To:	All Bidders and Plan Holders	Project No. 04107-0032
Re:	Addendum No. 1	Provided Via E-Mail, Lexington County Website, & Demandstar
Project:	Transfer Station Floor Repair at the Edmund Landfill in Lexington County, South Carolina	
Date:	August 1, 2014	
Bid Date:	August 8, 2014 @ 3:00 P.M.	Page 1 of 2

The following changes are hereby made to the Bid Documents and Specifications for the Transfer Station Floor Repair at the Edmund Landfill in Lexington County, South Carolina.

SK-C-1

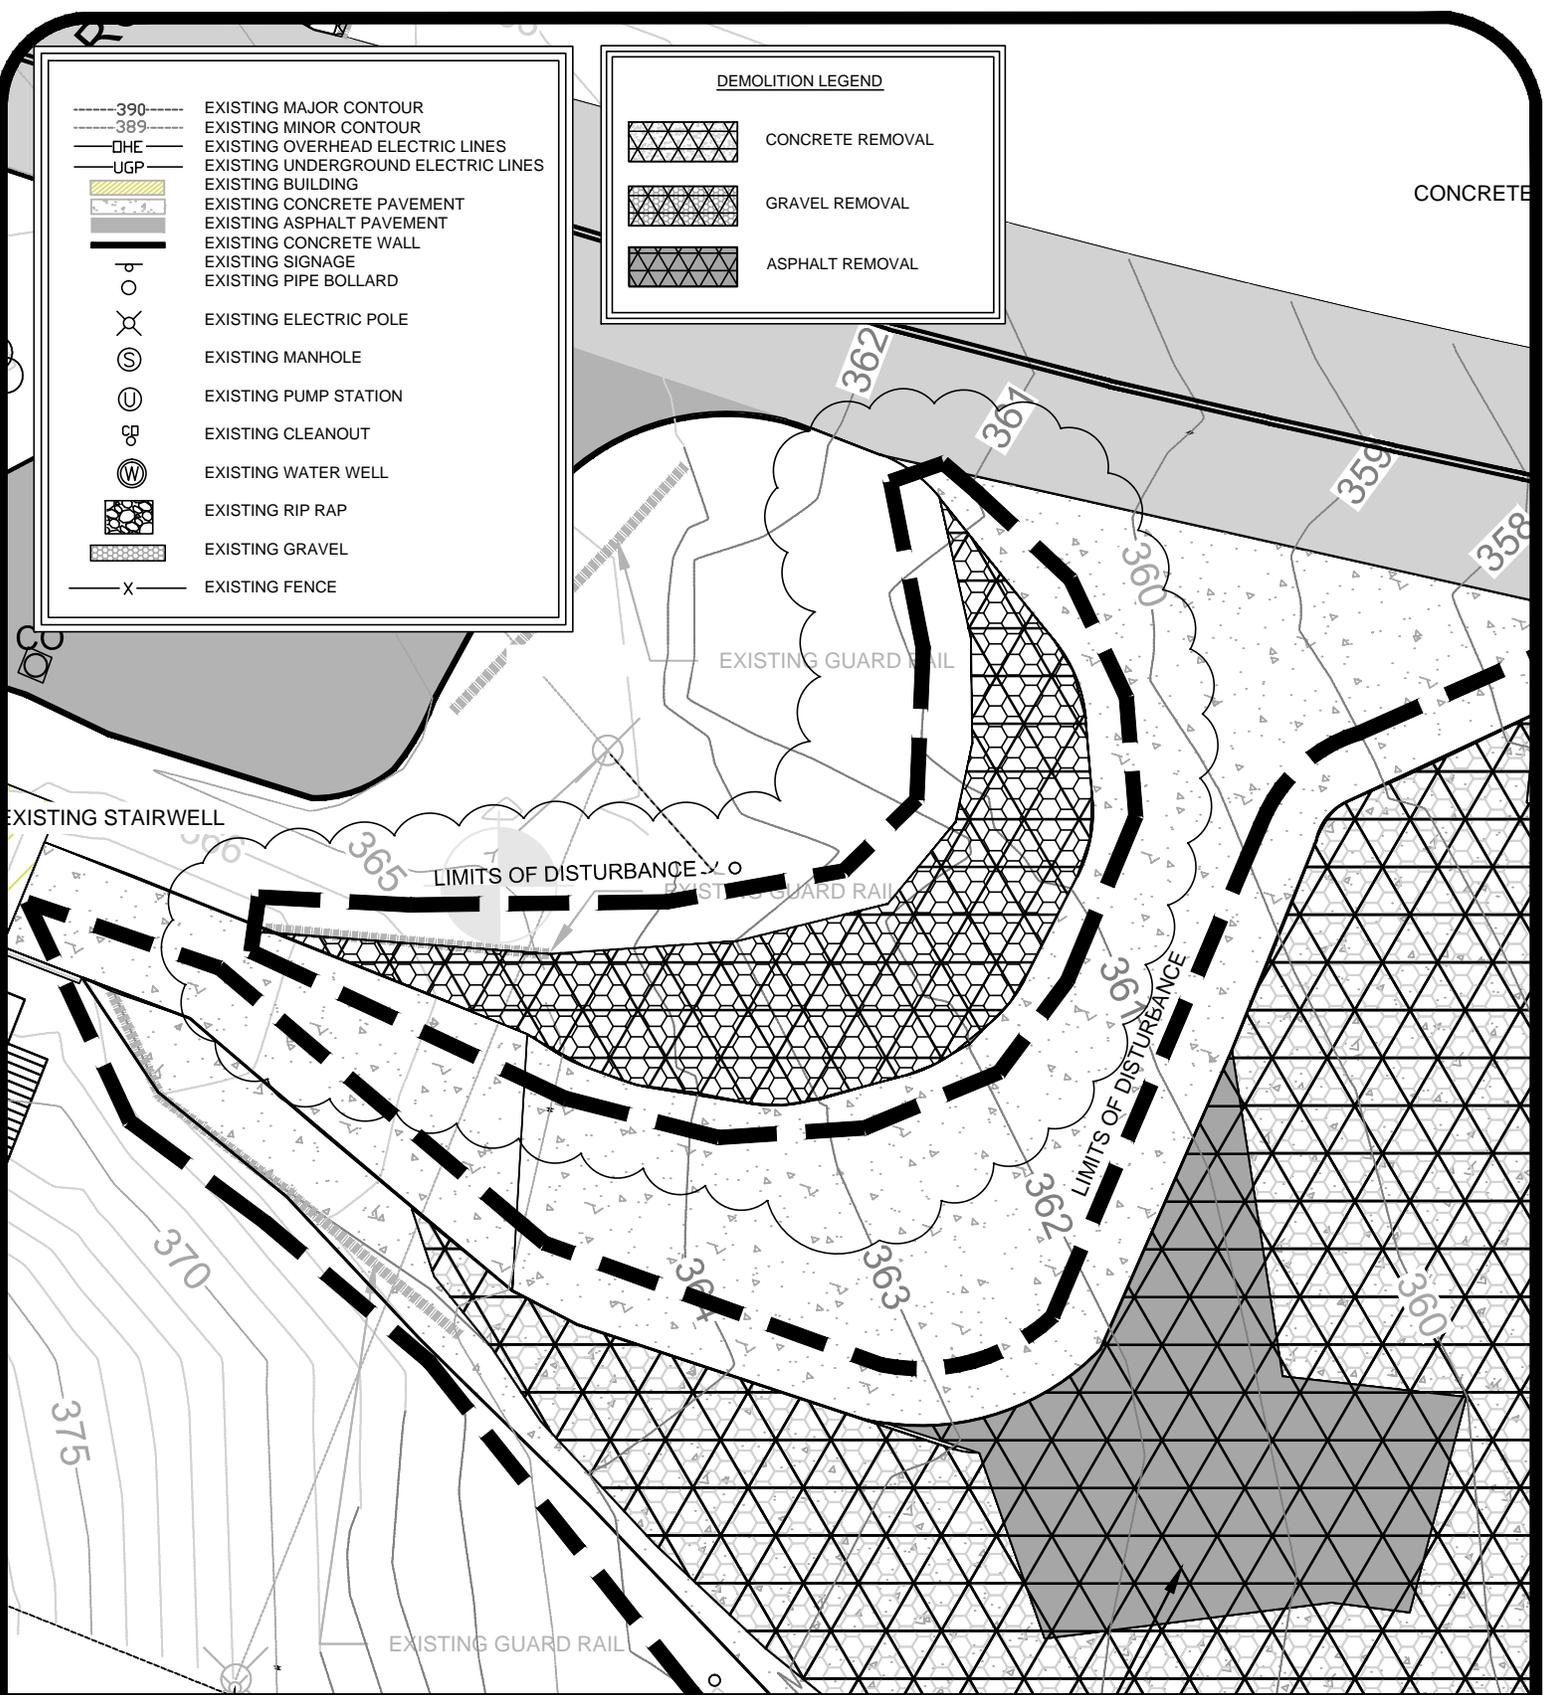
- A. Base Bid Option #2 includes a proposed addition to the scope of work of approximately 160 SF of concrete. The proposed addition of concrete will be located within the inner radius of the entrance drive to the concrete pad located east of the Transfer Station in accordance with SK-C-1 and SK-C-2 prepared by Alliance Consulting Engineers, Inc. dated July 30, 2014.
